Mask Set Errata for Mask 1L31N

This mask set errata applies to the mask 1L31N for these products:

- MC68HC908EY16
- MC68HC908EY8

Figure 1. Maximum Time for Other Execution

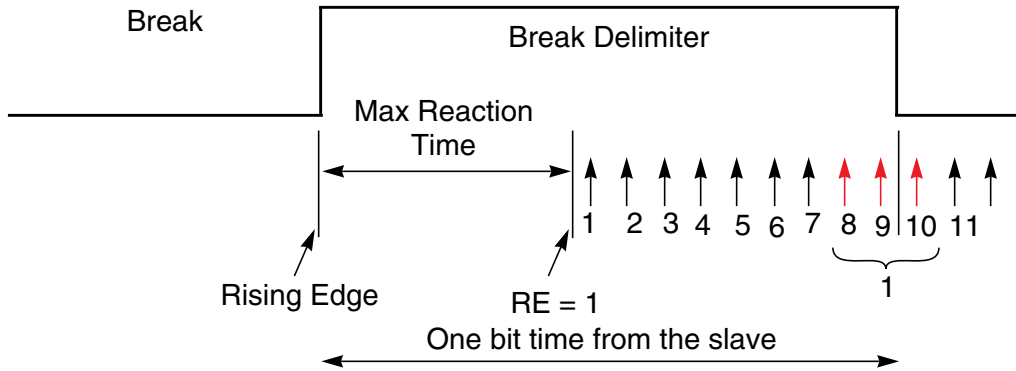
The time between when the rising edge actually appears on the receive pin and when the receiver is switched back on is finite and is governed by the timing of the falling edge of the delimiter. The receiver must be switched back on no later than 9/16th of a bit time before the end of the delimiter. See [Figure 1](#).

From [Figure 1](#), we also see that the “Maximum Reaction Time” is 7/16th slave bit-time.

The Maximum Reaction Time for this example system is $7/16 \times (44.5 \mu\text{s}) = 19.47 \mu\text{s}$.

From the instant the rising edge appears on the receive pin (detected via the arbiter AFIN bit or a timer interrupt), the software has to switch the receiver OFF and back ON within 19.47 μs .

Because ground shift in the physical layer might also affect the timing of the falling edge of the START bit of the 0x55 synch byte (i.e., the end of the delimiter), best design practices suggest that the switching of the receiver should be done as quickly as possible after the rising edge is detected. The maximum reaction time calculated above should be treated as a guideline only.
